The Residences at Coleridge Coast

Notice of Intent
#006-1606

updated on **December 5, 2018**

submitted to **Boston Conservation Commission**

BB SITE SECTION AT HARBORWALK
SCALE 1/4" = 1' - 0" **BB**

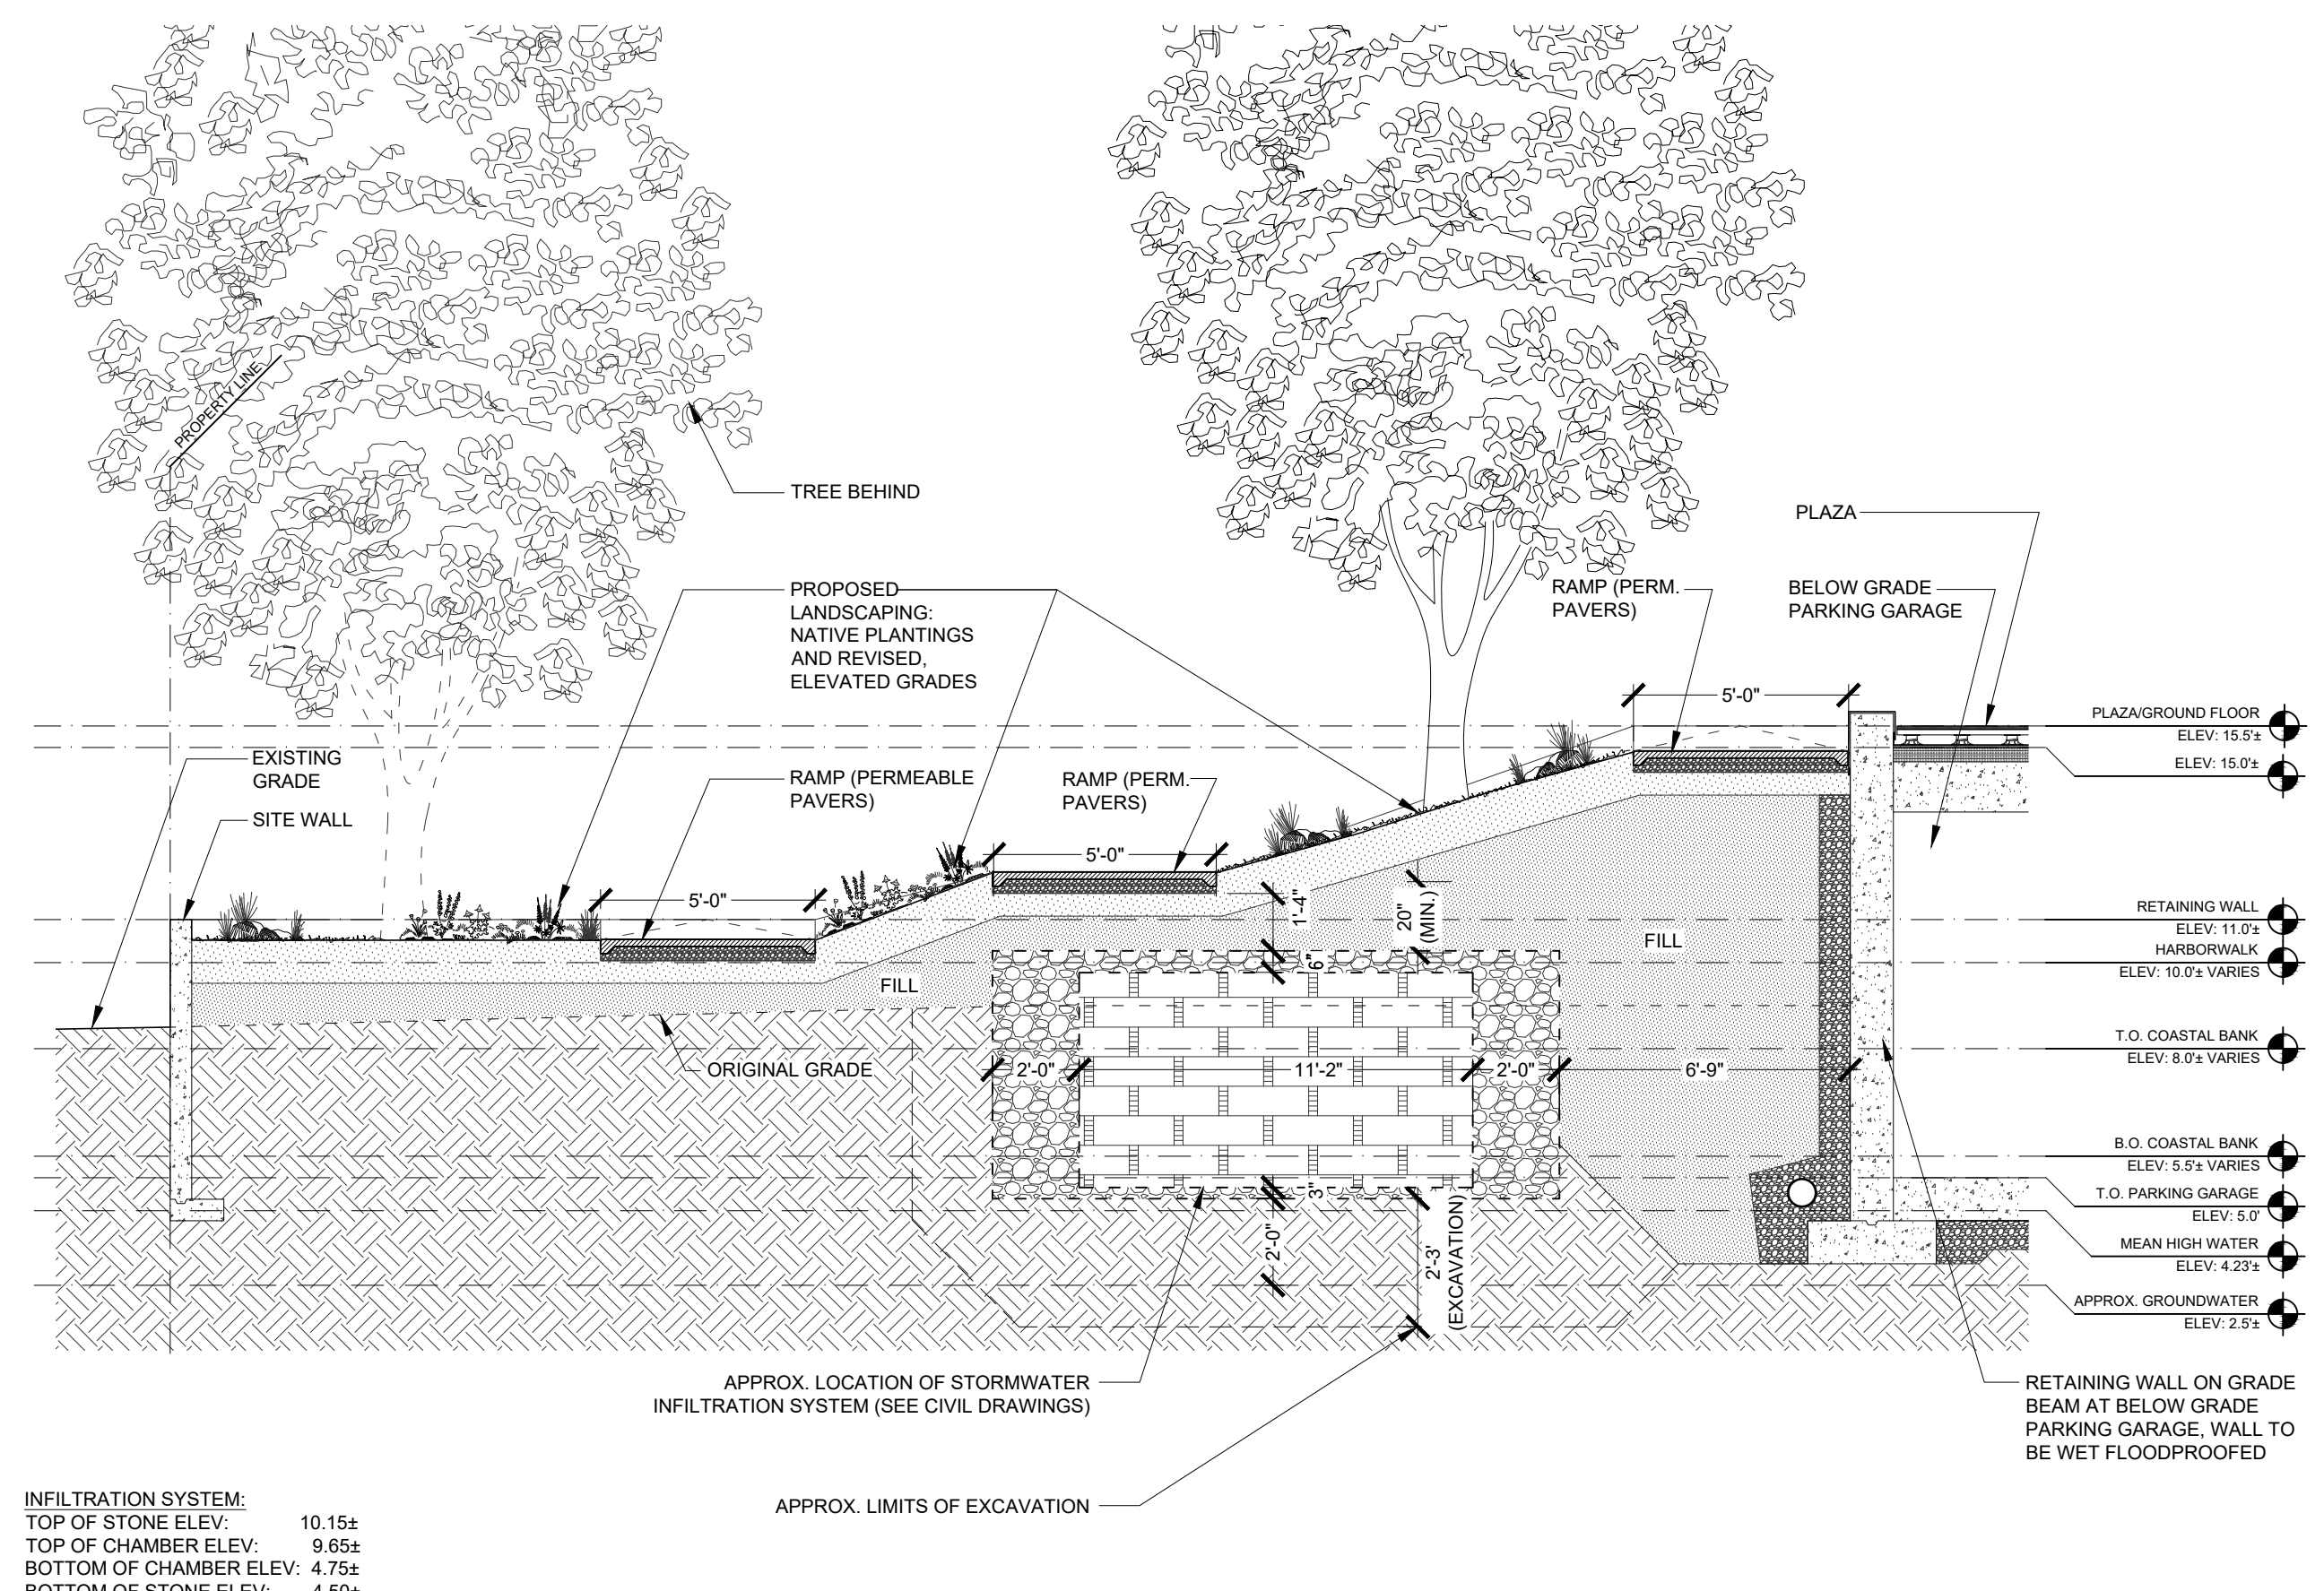
7.	<p>Figure 9 suggests you may be creating a vertical coastal bank.</p> <p><i>Response: Figure 9 is an old drawing that is no longer applicable to the design and should be disregarded. Please refer to revised Harborwalk detail in Attachment G – Plans.</i></p>

No.	Question/Response
9.	<p>[Provide] stamped plan that details how the installation of the Harborwalk will or will not affect the stability of the bank and what will be done to ensure the longevity of the bank.</p> <p>Provide stamped cross section plan of coastal bank and Harborwalk</p> <p>[Provide] stamped plan that shows where the coastal bank will be located with the proposed grading plan</p> <p><i>Response: No work to, or within, the Coastal Bank is currently proposed. Physical barriers (i.e., construction fencing) will be installed 2 to 5 feet inland of the coastal bank to minimize impacts and provide a visual and physical “no work” barrier during construction. No access or work will be performed from the Coastal Bank side of the Project Site. The helical piles will be installed a minimum of 6 feet from the Top of Coastal Bank and inside of the temporary construction fencing. The combination of during-construction protection of the Coastal Bank, the additional 2-foot setback from the Coastal Bank, and the 6-foot helical pile setback will minimize potential impacts and protect and maintain the existing condition of the Coastal Bank. See responses to questions No. 2 and 3.</i></p>
